**From:** Wesley Held  
**To:** <arspears@southernco.com>, <jtdavis@southernco.com>  
**Date:** 8/31/2007 4:05:06 PM  
**Subject:** Section 2.5 Part 1 of SER  
**cc:** "Christian Araguas" <CJA2@nrc.gov>

## **2.5 Geology, Seismology, and Geotechnical Engineering**

In Section 2.5, “Geology, Seismology, and Geotechnical Engineering,” of the VEGP SSAR, the applicant described geologic, seismic, and geotechnical engineering properties of the VEGP ESP site. SSAR Section 2.5.1, “Basic Geologic and Seismic Information,” presents information on geologic and seismic characteristics of the VEGP site and region surrounding the site. SSAR Section 2.5.2, “Vibratory Ground Motion,” describes the vibratory ground motion assessment for the ESP site through a PSHA and develops the SSE ground motion. SSAR Section 2.5.3, “Surface Faulting,” evaluates the potential for surface tectonic and non-tectonic deformation at the ESP site. SSAR Sections 2.5.4, “Stability of Subsurface Materials and Foundations,” 2.5.5, “Stability of Slopes,” and 2.5.6, “Embankments and Dams,” describe foundation and subsurface material stability at the ESP site.

Figure 2.5.1-4 - Local Charleston Tectonic Features (Reproduced from SSAR Figure 2.5.1-19)

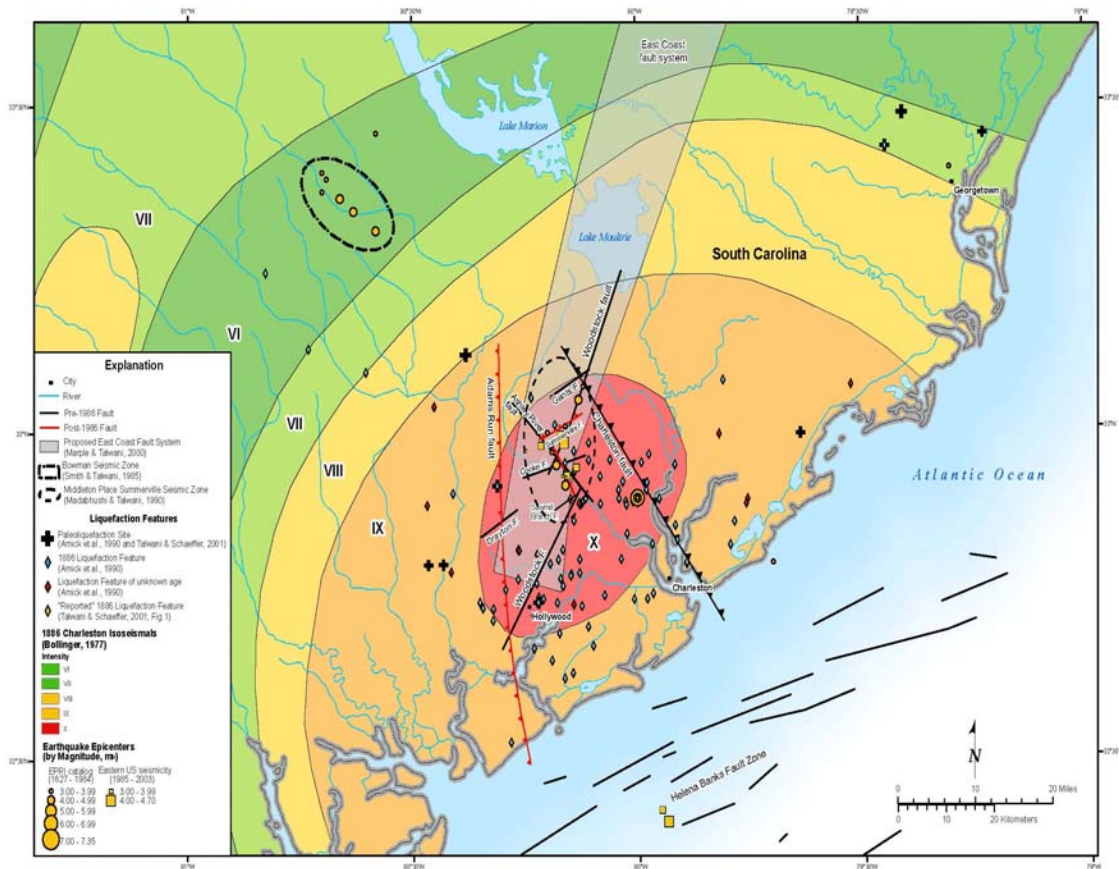
3. The applicant described the Adams Run seismic zone, located within the meizoseismal area of the 1886 Charleston earthquake as being defined by four earthquakes with magnitudes less than M2.5. Three of these four earthquakes occurred over a 2-day period in December 1977. This seismic zone occurs about 120 km (75 mi) east-southeast of the VEGP site and is not shown in Figure 2.5.1-4 as the text indicates.

Figure 2.5.2-2 - Alternative geometries comprising the UCSS model updated Charleston seismic source (reproduced from SSAR Figure 2.5.2-9)

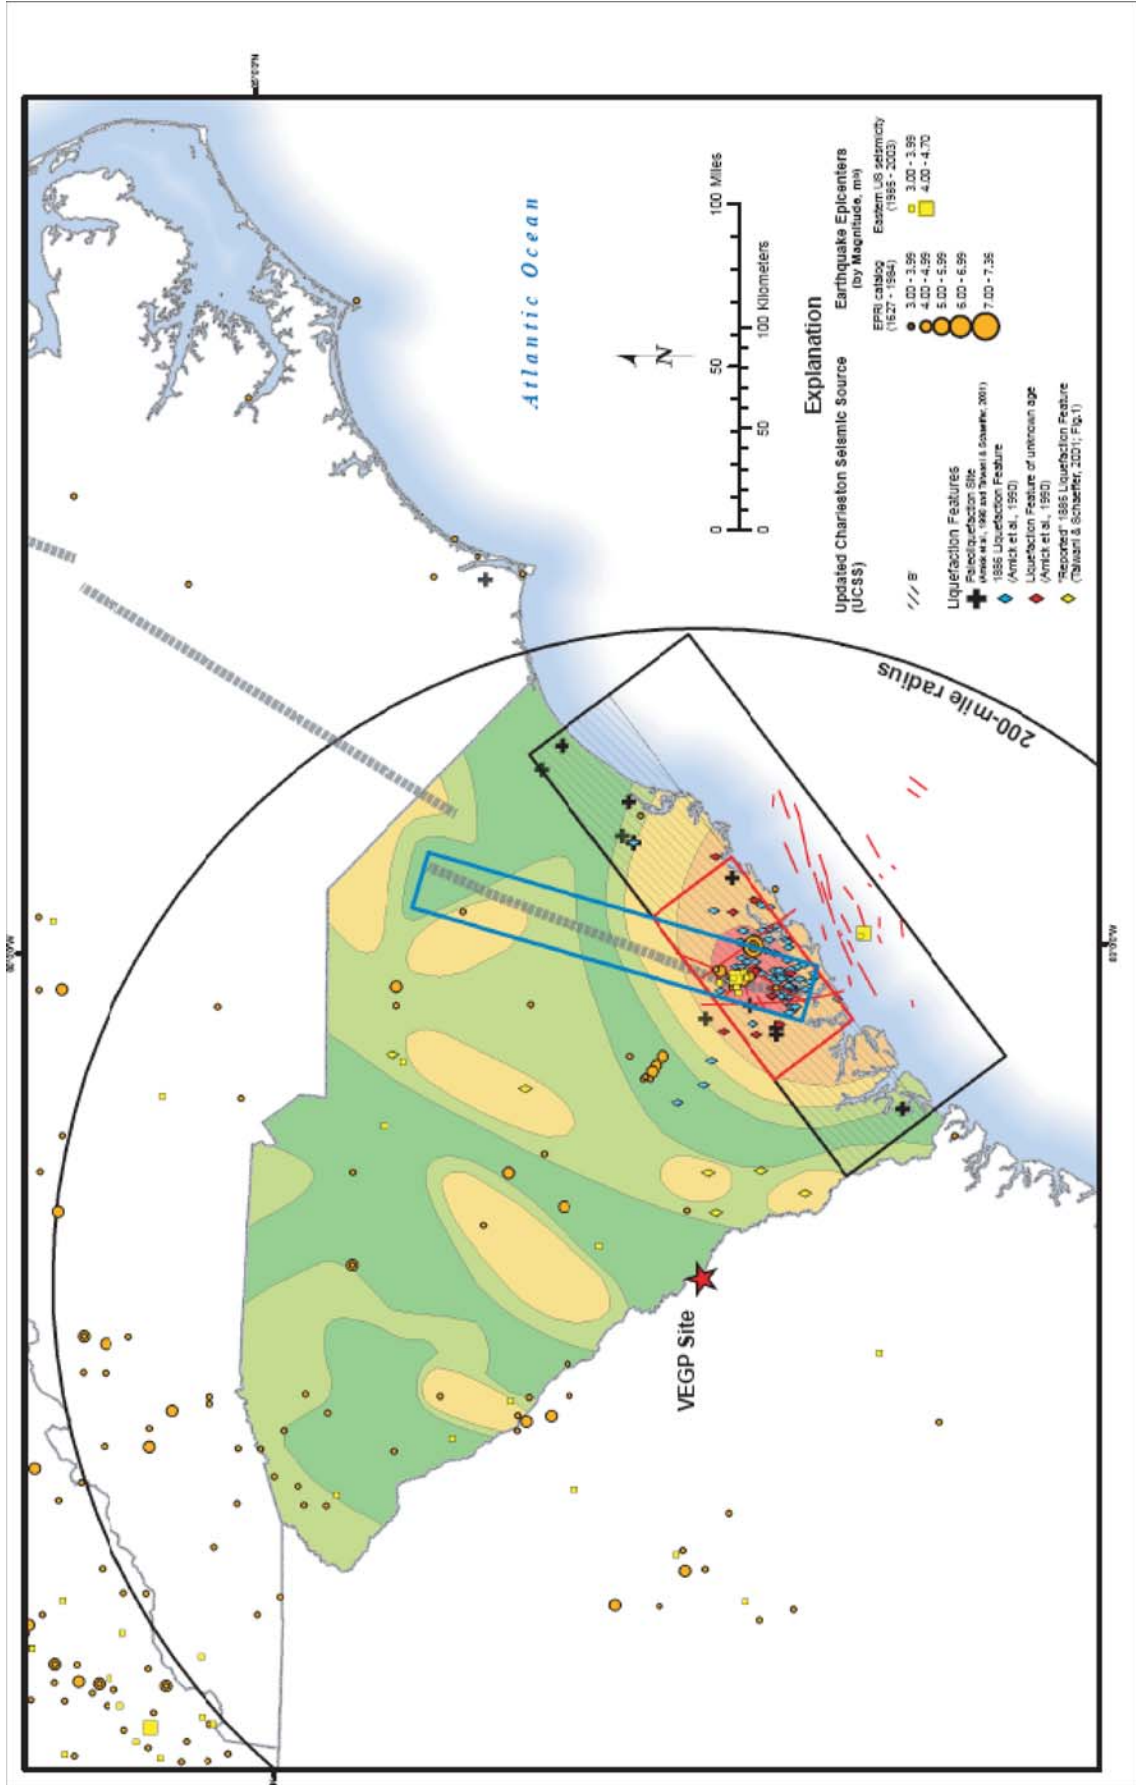
Charleston Seismic Source Zone Geometries. For its update of the Charleston seismic source zone, the applicant developed new source zone boundaries. Specifically, as described in SSAR Section 2.5.2.2.4, the applicant developed four, mutually exclusive source zone geometries, referred to as A, B, B', and C, to represent the Charleston seismic source. These four source zones are shown in SER Figure 2.5.2-2 (reproduced from SSAR Figure 2.5.2-9). SSAR Section 2.5.2.2.4.1 states that the width of Geometry B is 80 kilometers (50 miles). However, SSAR Figure 2.5.2-9 (and SER Figure 2.5.2-2) show that

the width of Geometry B is 100 kilometers (62 miles). In RAI 2.5.2-14, the staff asked the applicant to provide the actual dimensions of Geometry B used for the UCSS. In response, the applicant stated that the width of UCSS Geometry B is 100 kilometers and not 80 kilometers, as stated in SSAR Section 2.5.2.2.4.1. Based on the applicant's clarification of the width of source zone B, the staff concludes that the source referred to as Geometry B in SSAR Figure 2.5.2-9 is accurate.

Figure 2.5.2-11 - Comparison of the staff's 1-Hz hazard curves for the ETSZ for magnitudes ranging from M 6.0 to M 7.8

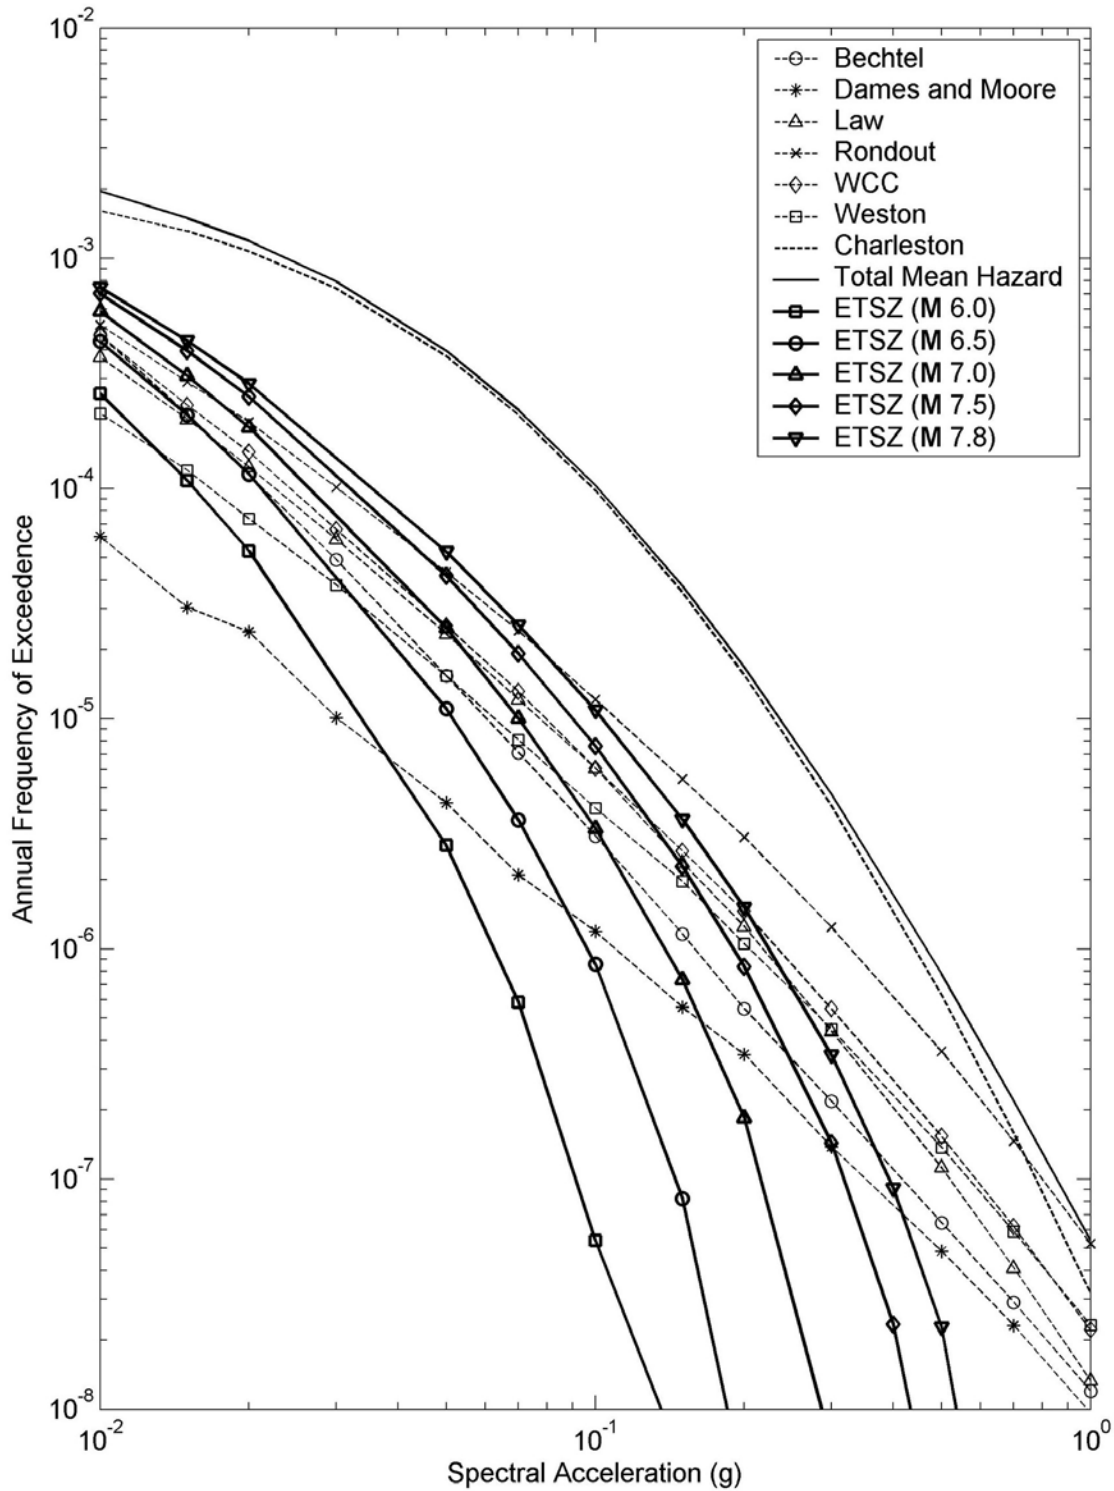
To validate the applicant’s claim that the ETSZ hazard results are insignificant compared to the Charleston seismic source, the staff did a confirmatory analysis. The staff performed hazard calculations using maximum magnitudes for the ETSZ that ranged from M 6.0 to M 7.8. This magnitude range reflects more recent  $M_{max}$  values assigned to the ETSZ, as shown in SER Table 2.2.5-6. SER Figure 2.5.2-11 shows the staff’s 1-Hz hazard curves for the ETSZ using this range of  $M_{max}$  values. SER Figure 2.5.2-11 also shows the applicant’s total mean hazard curve and the Charleston seismic source zone contribution for comparison. The staff’s results show that, although the Charleston seismic source zone clearly dominates the 1-Hz hazard, the contribution from the ETSZ for some of the larger  $M_{max}$  values (greater than 7.0) may contribute significantly more than 1 percent to the total hazard for the ESP site.

The staff concludes that, despite the uncertainty regarding the potential for large earthquakes within the ETSZ, the results of post-EPRI source characterizations for the ETSZ suggest that the EPRI EST characterization of the ETSZ needs to be updated. The results of the staff’s confirmatory analysis do confirm the applicant’s assertion that the Charleston seismic source dominates the 1-Hz hazard. However, the staff concludes that the contribution of the ETSZ at the ESP site may be significant enough to warrant inclusion in the applicant’s PSHA, if larger  $M_{max}$  values are considered. This is **Open Item 2.5-3**.

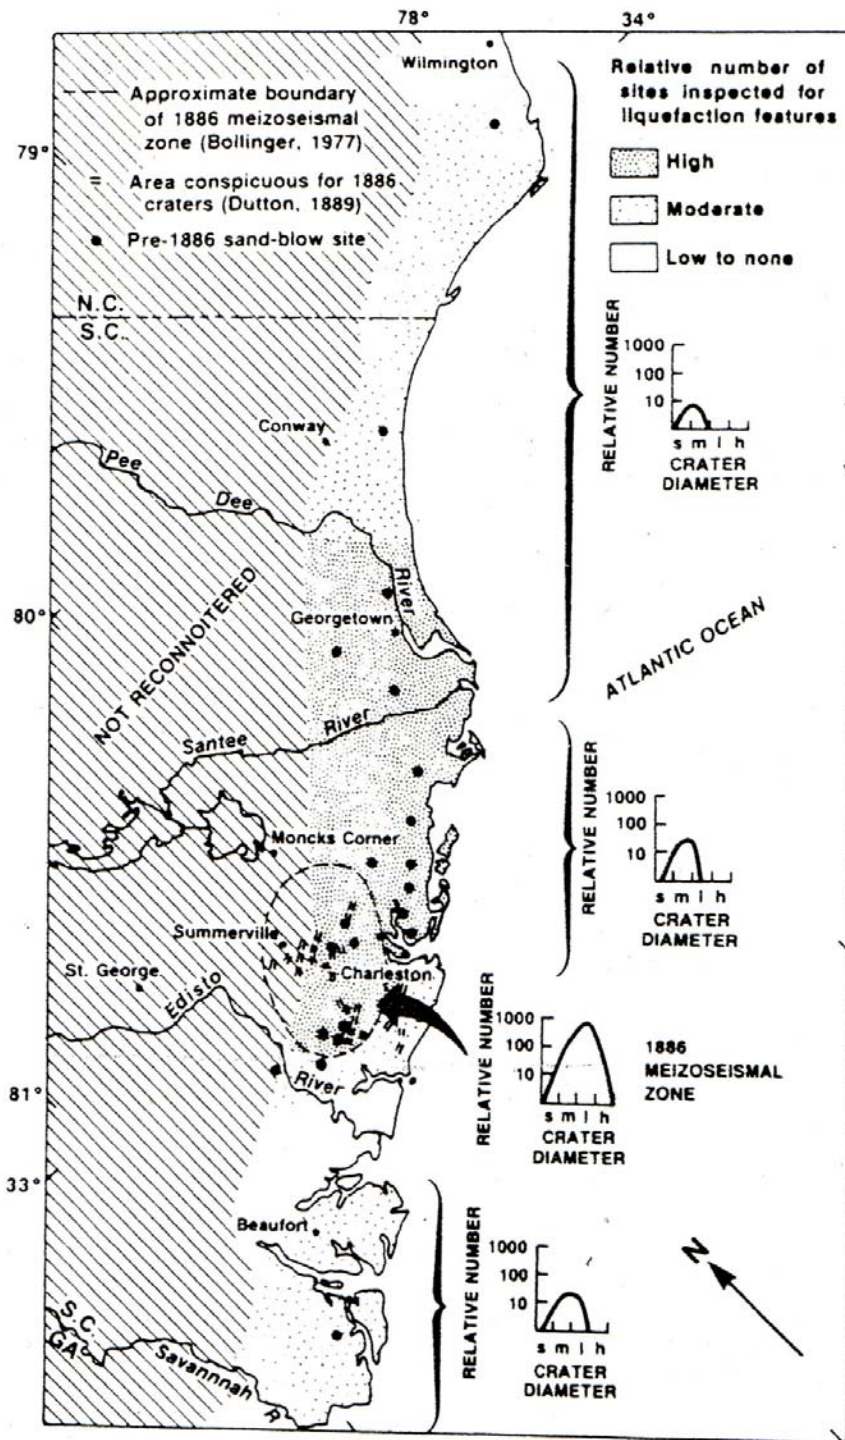
The staff also reviewed the study of Obermeier et al. (1989). Obermeier et al. (1989) conclude that, "Both the size and relative abundance of pre-1886 craters are greater in the vicinity of Charleston (particularly in the 1886 meizoseismal zone) than elsewhere, even though the susceptibility to earthquake-induced liquefaction is approximately the same at many places throughout this coastal region." Figure 4 of Obermeier et al. (1989), reproduced as SER Figure 2.5.2-12, depicts the sizes of various prehistoric liquefaction features and demonstrates that the largest craters of all ages concentrate near Charleston. The staff notes that the figure cannot exclude the possibility that one (or more) of the large prehistoric earthquakes created its (or their) largest liquefaction features elsewhere. However, Obermeier's (1989) figure shows four size classes of craters, with the largest prehistoric craters (wider than 3 meters) present only in the 1886 meizoseismal area. Only smaller craters are known farther south and north. Obermeier (1989) favors attributing some of these distant, small-to-medium-sized craters to infrequent moderate earthquakes at two separate sources far north and south of Charleston. The epicentral regions of 1886-sized earthquakes should have abundant craters wider than 3 meters, and they have been found only near Charleston. Sparse exposures preclude saying much about crater sizes between Beaufort and the Edisto River, south of Charleston (Obermeier et al. 1989) and south of Geometry A. Thus, it is unlikely, but possible, that the paleoliquefaction record of a large earthquake's meizoseismal region could be concealed south of Geometry A. However, this small probability is accounted for by Geometries B and B', which span most of the length of South Carolina's coast. The absence of known abundant paleoliquefaction features in North Carolina and Georgia, despite searches there (Amick and Gelinis 1991), suggests that Geometries B and B' need not extend beyond South Carolina.

(62 miles) inland from the coast. The occurrence of a large earthquake inland of the coast would necessitate different Charleston source zone models. See Open Item 2.5-5.

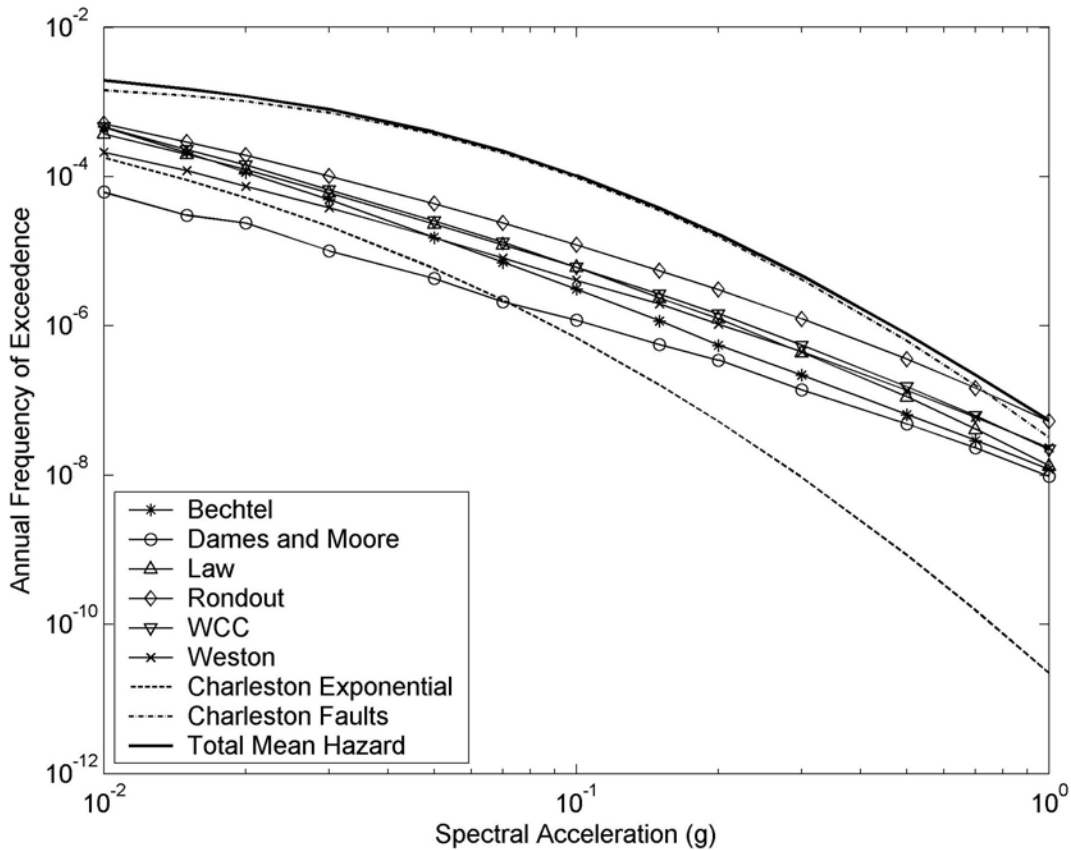
In order to determine the adequacy of the PSHA results, the staff, in RAI 2.5.2-1, requested the applicant to provide the 1- and 10-Hz mean hazard curves for each of the six EPRI ESTs, as well as the 1- and 10-Hz mean hazard curves for the UCSS model. In response to RAI 2.5.2-1, the applicant provided the requested hazard curves. SER Figures 2.5.2-13 and 2.5.2-14 show the applicant's 1-Hz and 10-Hz total mean hazard curves, as well as the hazard curves corresponding to each of the six EPRI EST seismic source model inputs. Both figures also show the hazard curves corresponding to the applicant's UCSS model.

As shown in SER Figure 2.5.2-13, for the 1-Hz hazard curves, the Charleston source dominates the overall hazard at the ESP site. In SER Figure 2.5.2-14, for the 10-Hz hazard curves, the contributions from each of the six ERPI seismic source models have a more significant contribution to the overall hazard.
